2.1 Level 3 extension

2.2 Plant screen

Aerial from north - as consented

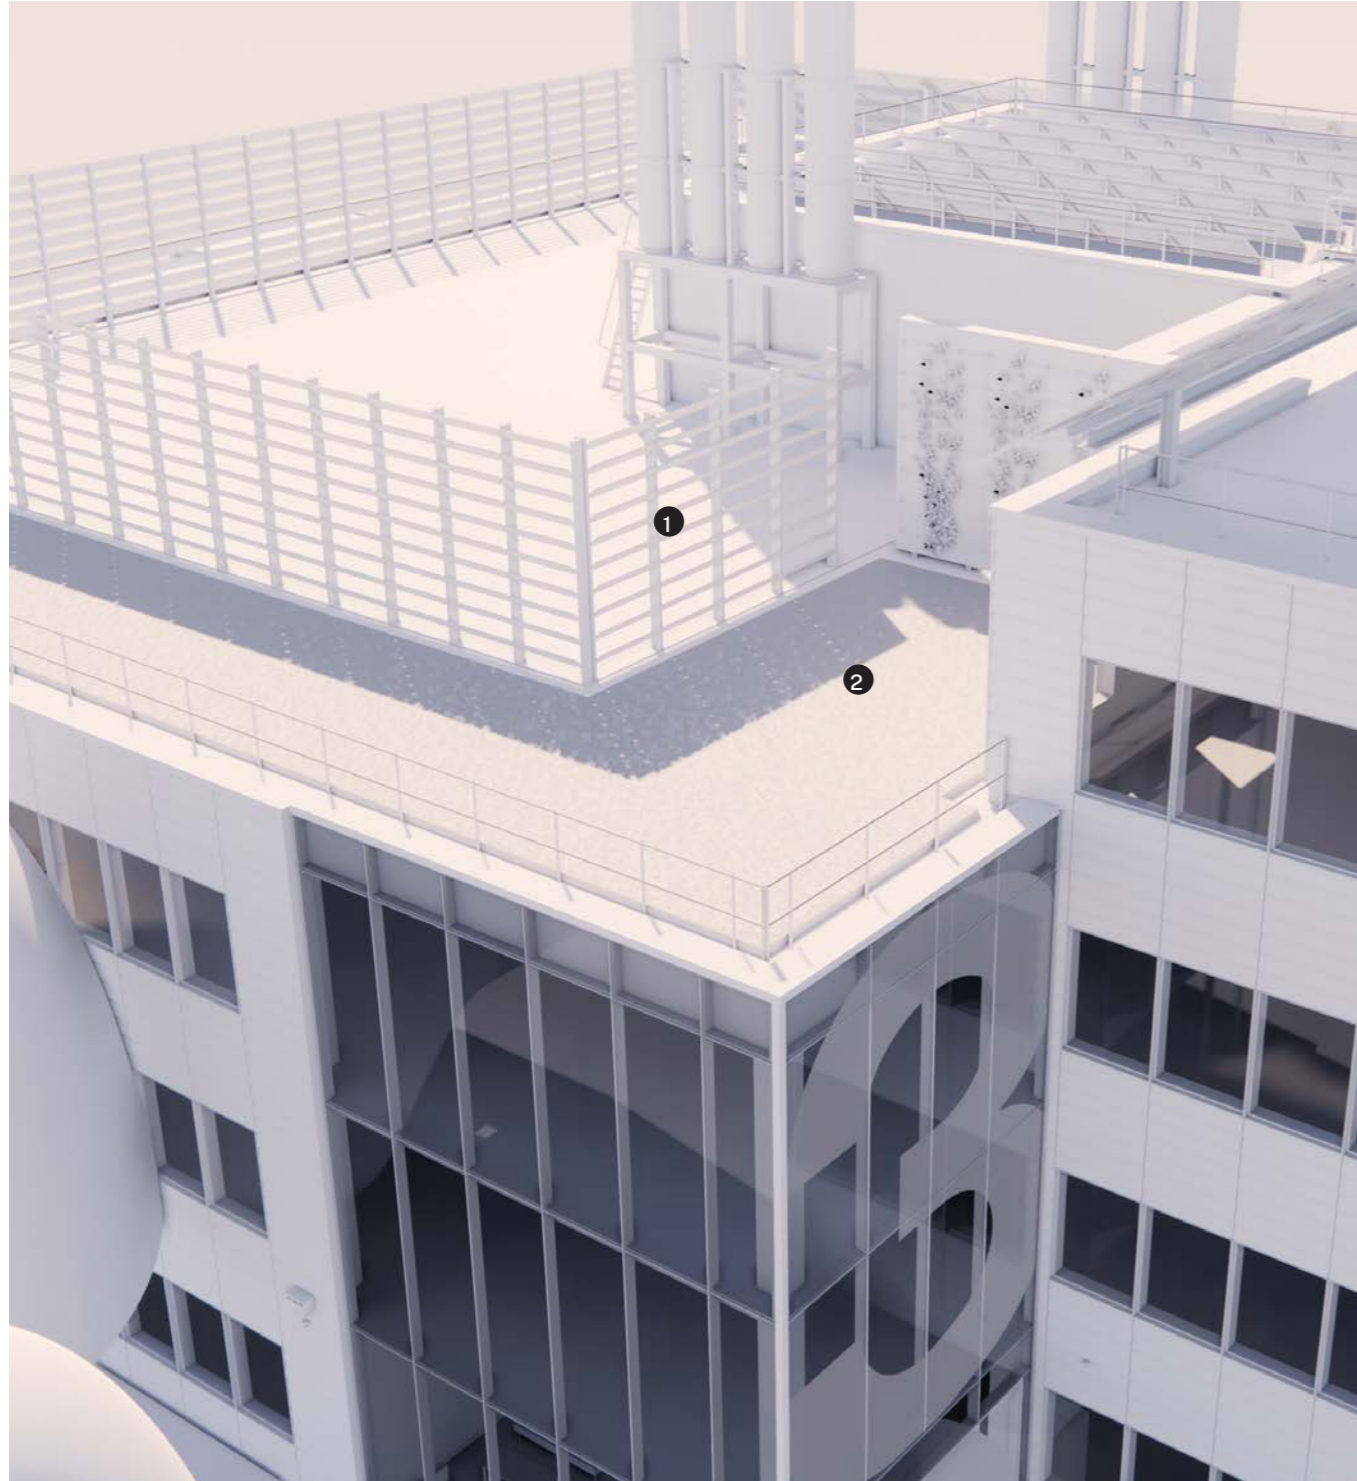
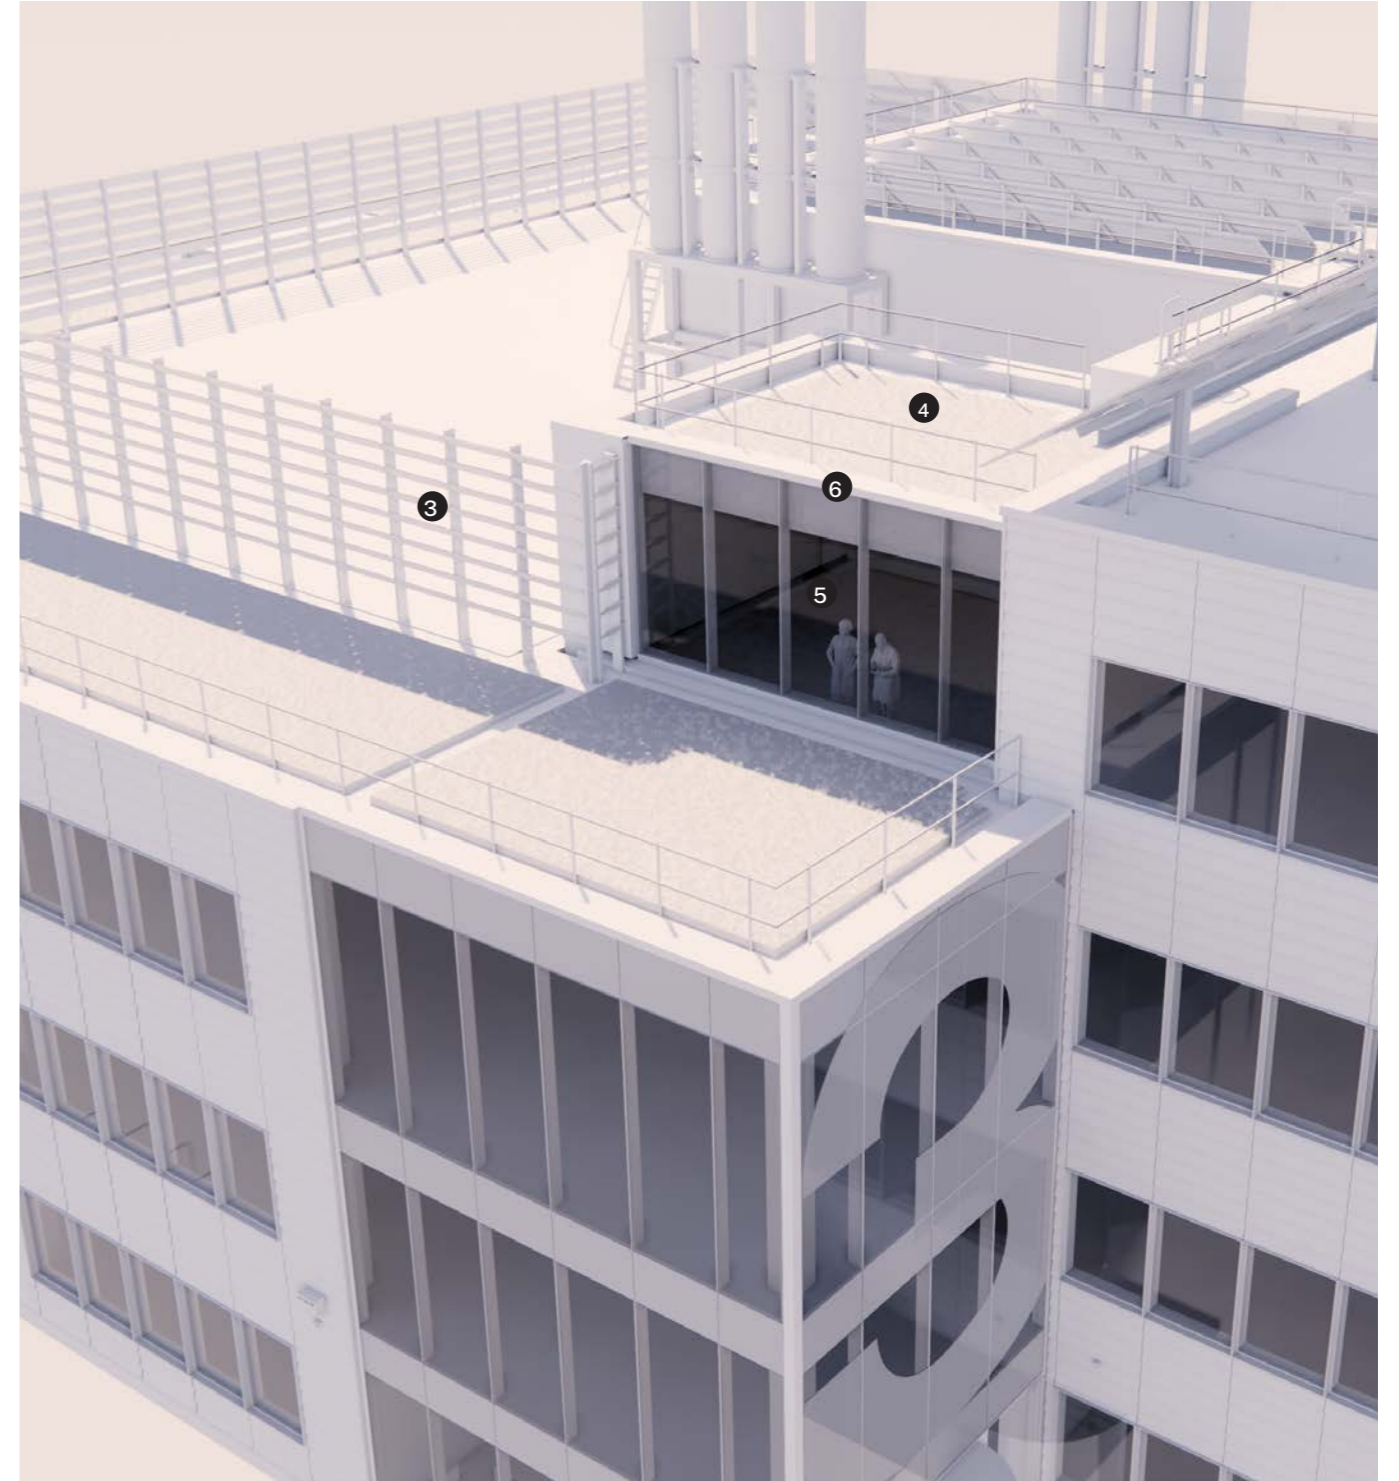
- ① Portion of plant screen to be removed
- ② Area of green roof to be replaced with sedum on extension roof

- ③ Plant screen moved back to provide additional green roof area
- ④ Sedum roof
- ⑤ Full-height glazing
- ⑥ Reduced parapet height compared to the remainder of L03 to sit within parameter plan heights

NE elevation with revised L03 extension and consented height parameters overlaid

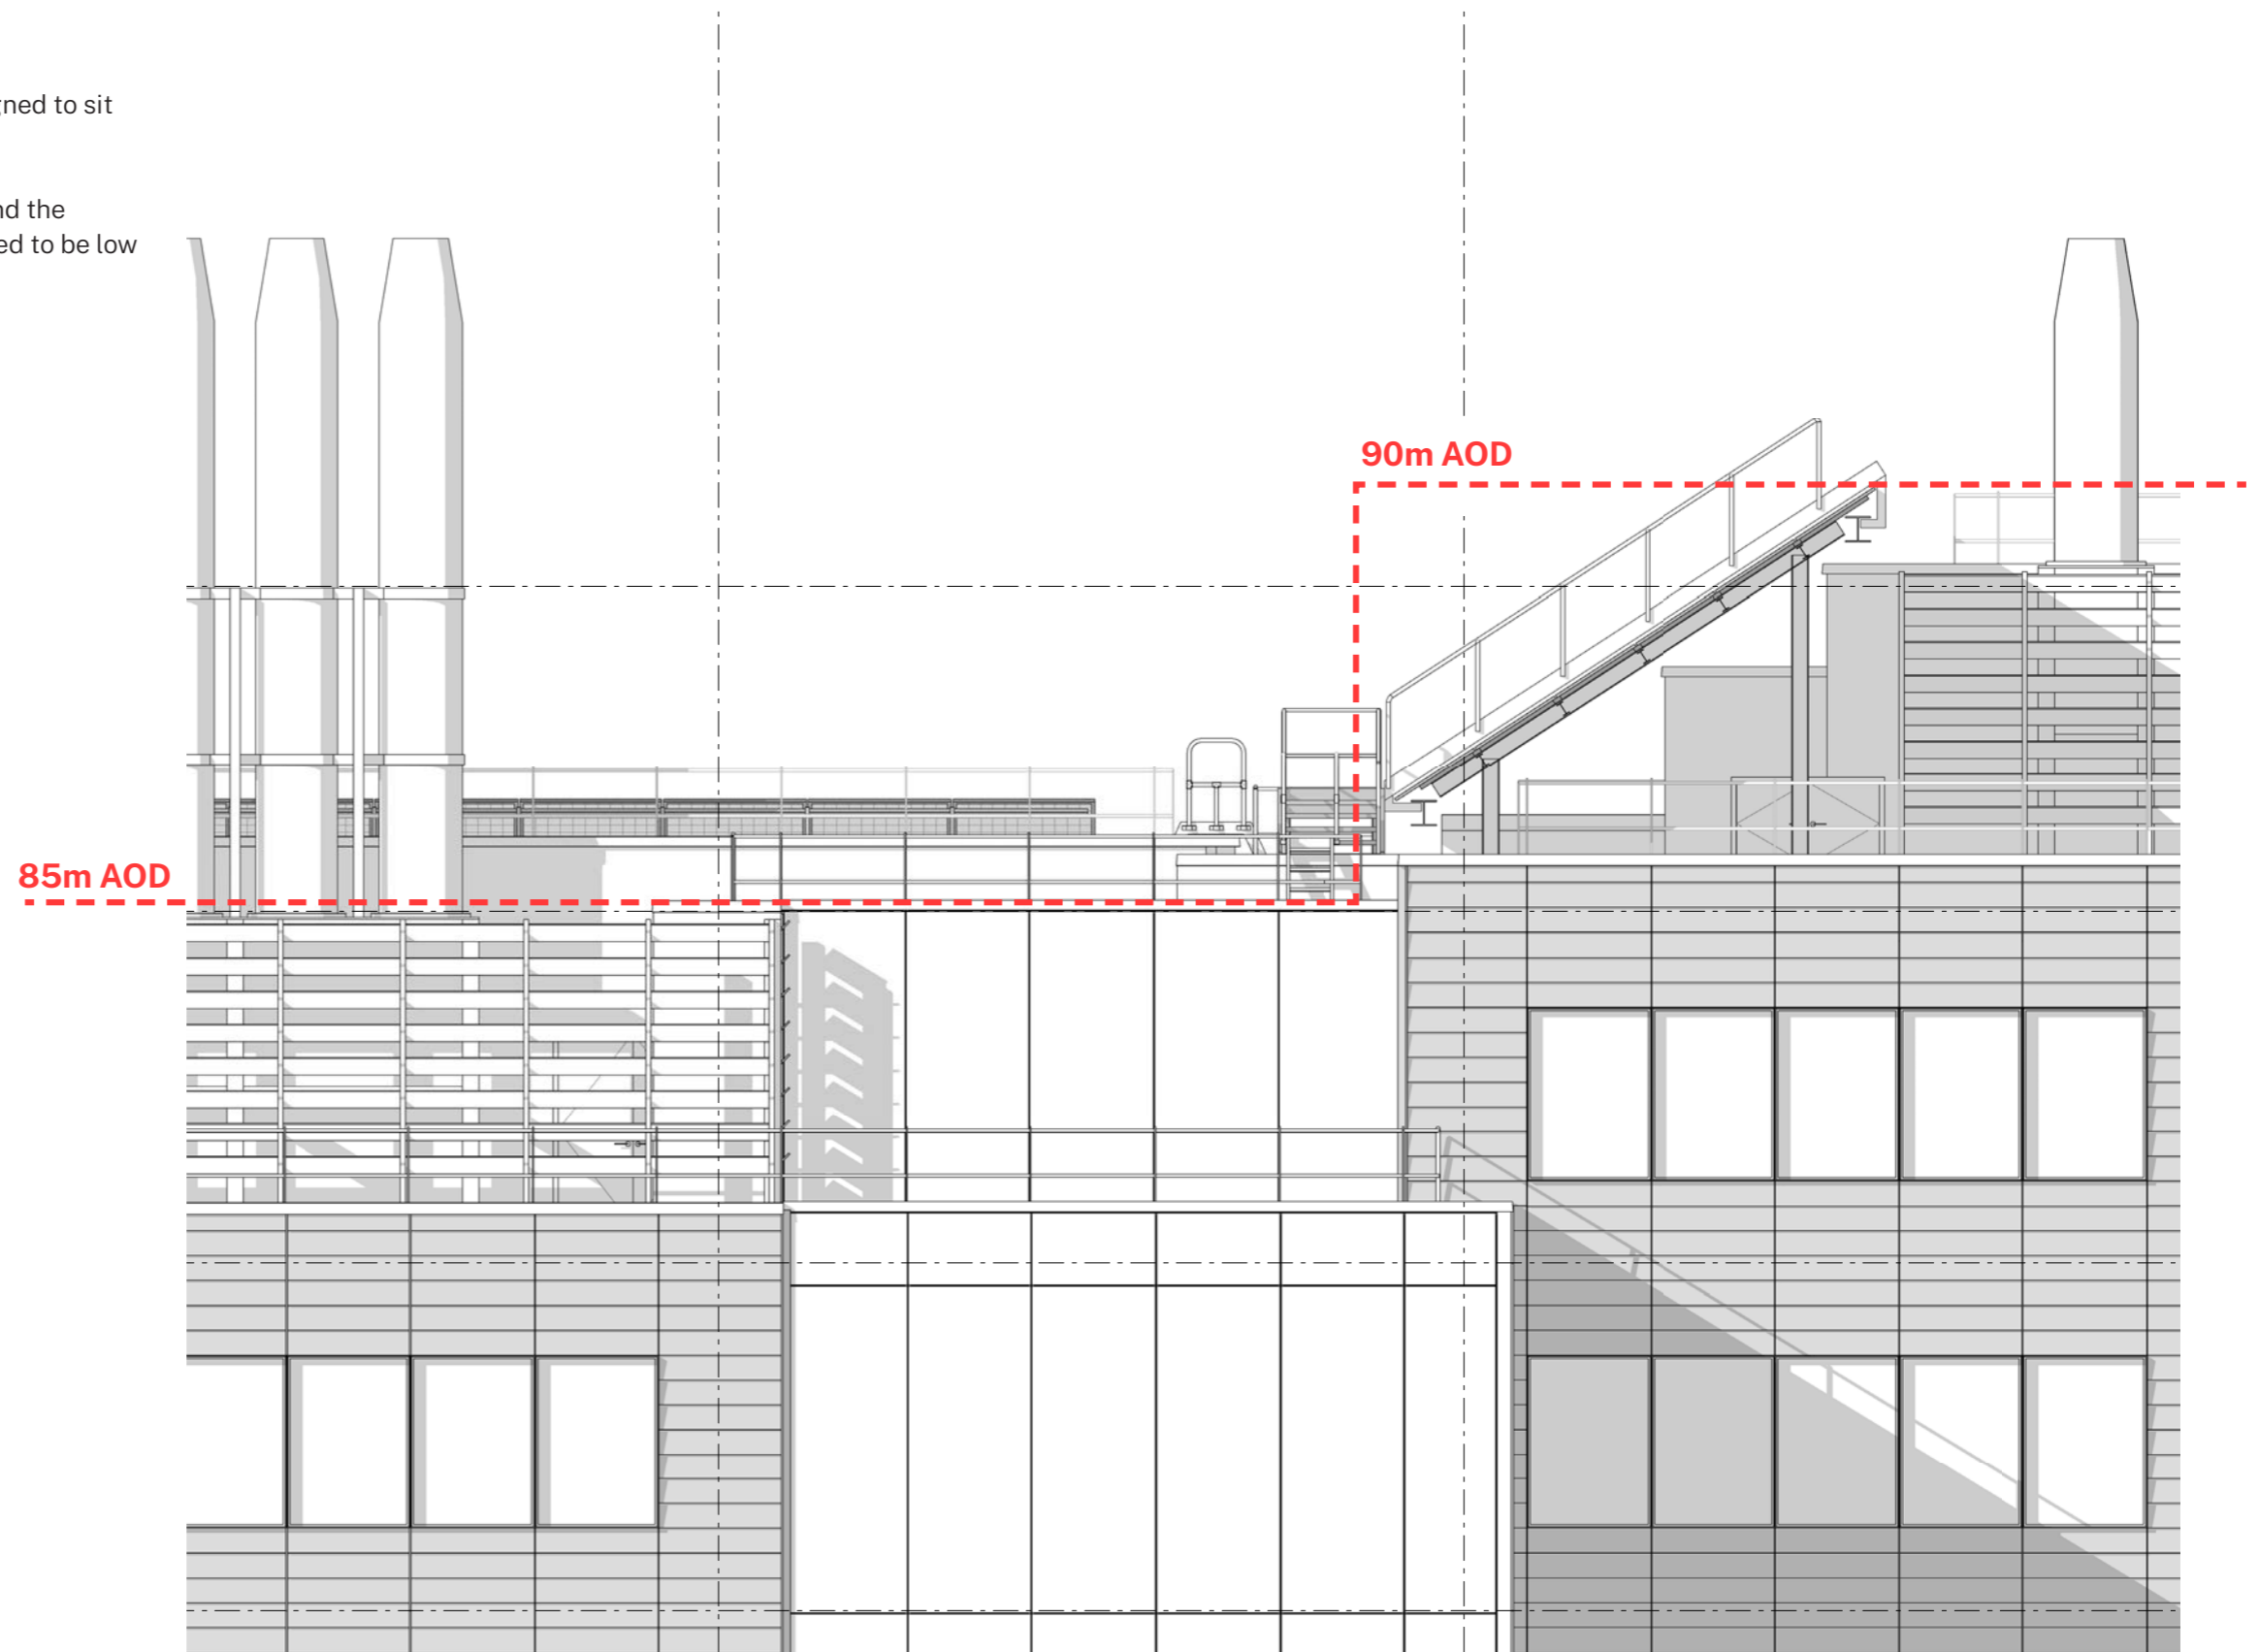
The roof parapet of the extension is designed to sit within the consented parameter heights.

A roof maintenance balustrade sits beyond the parameter by circa. 750mm but is designed to be low visibility.

North-east elevation-proposed, with the extent of plant screen omitted in red

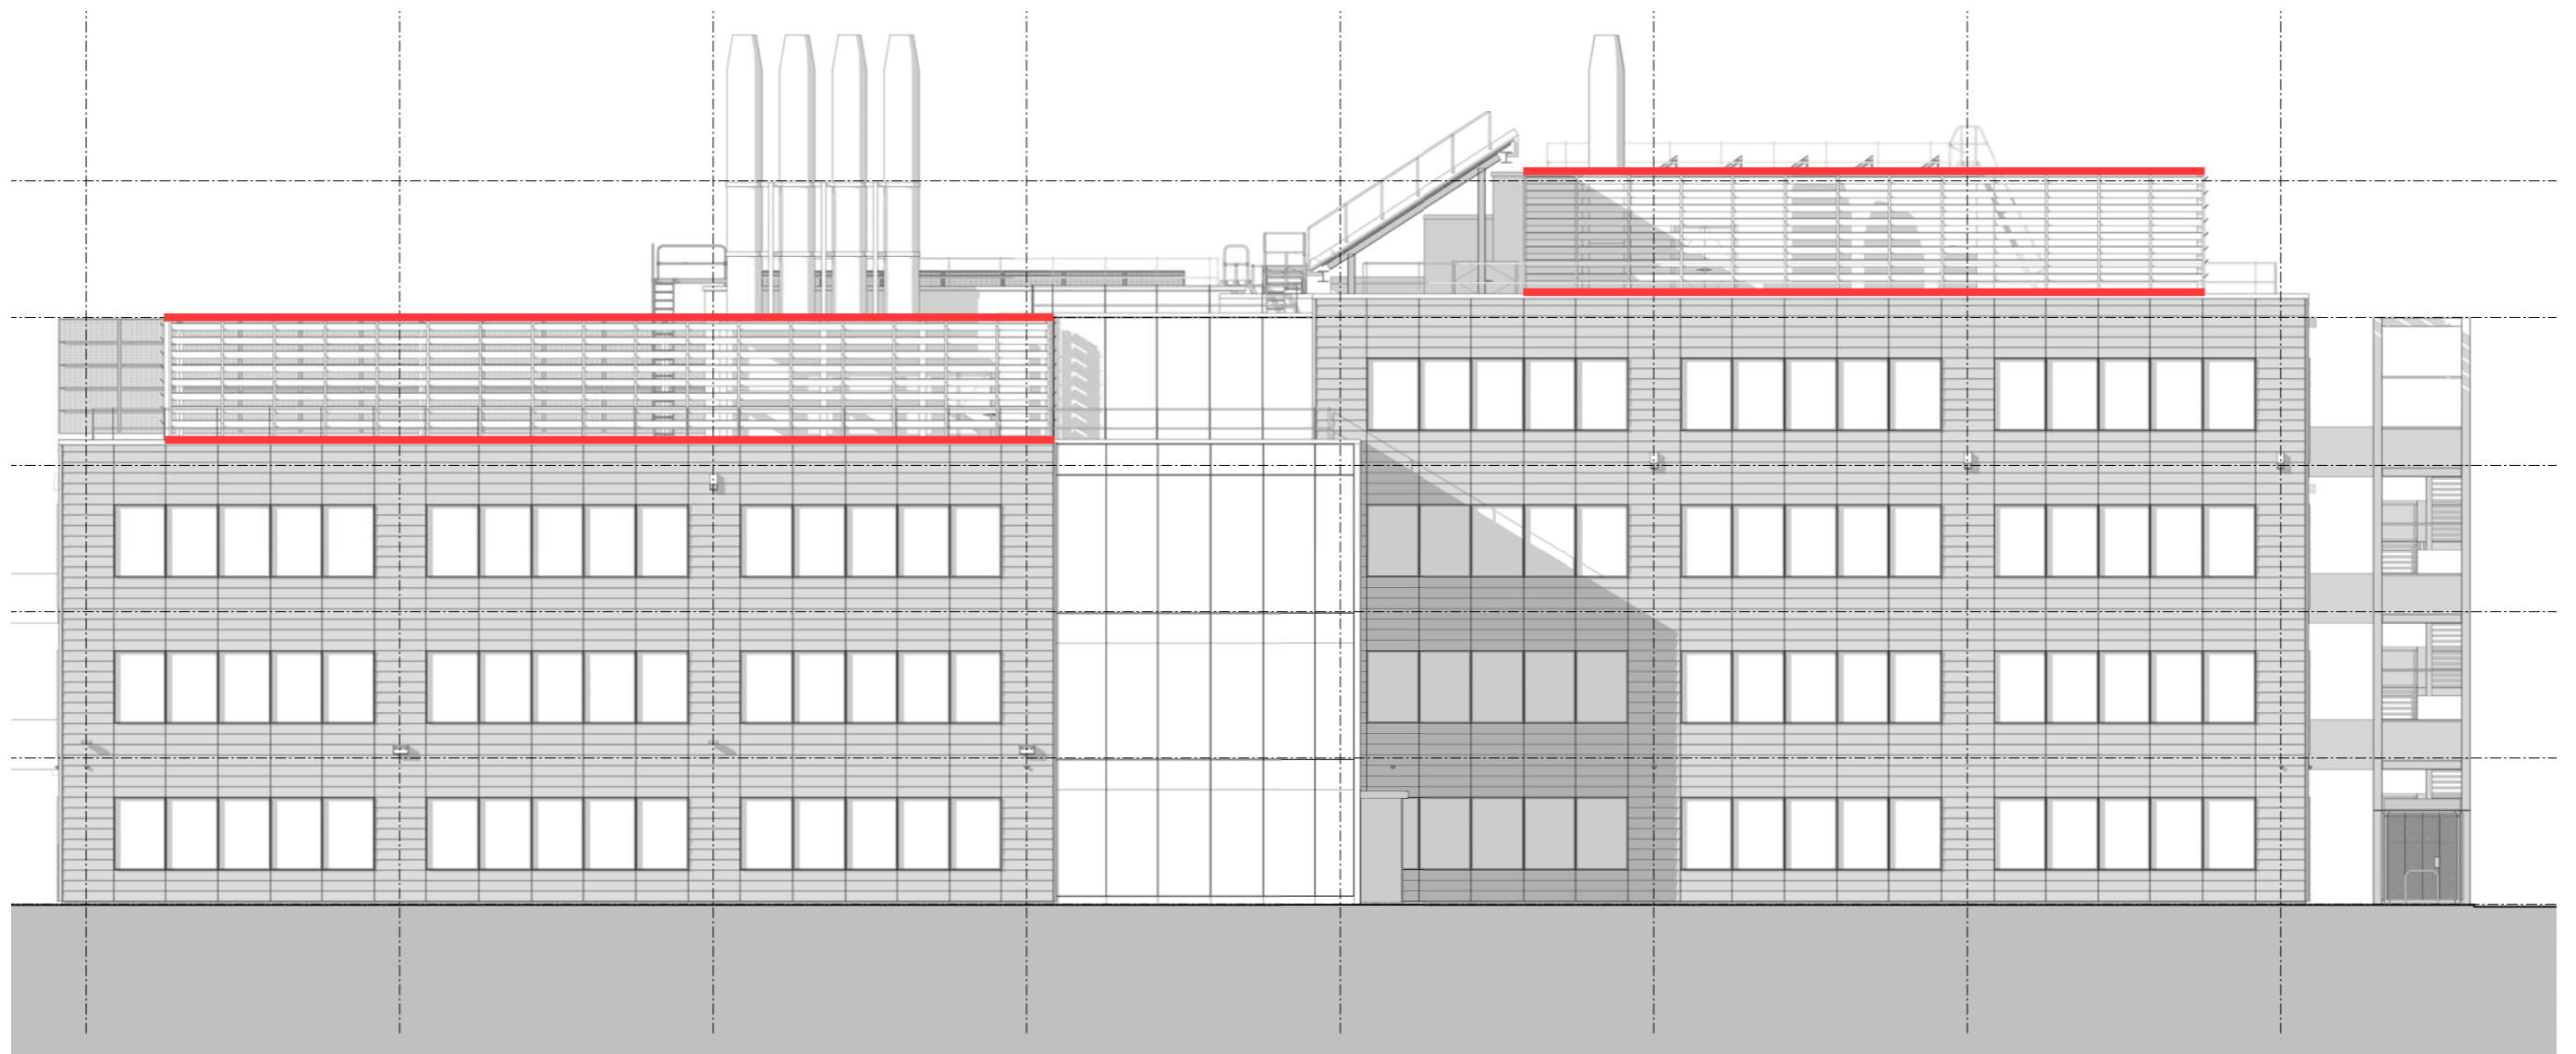
Following more detailed design and modelling of the roof level plant equipment since the original planning application was submitted, it has been possible to reduce the height of the plant screen by approximately 300mm.

It is also proposed to remove the bottom louvre blade of the screen as the adjacent facade parapet means it is redundant.

These changes will help reduce material usage and reduce embodied carbon as a result.
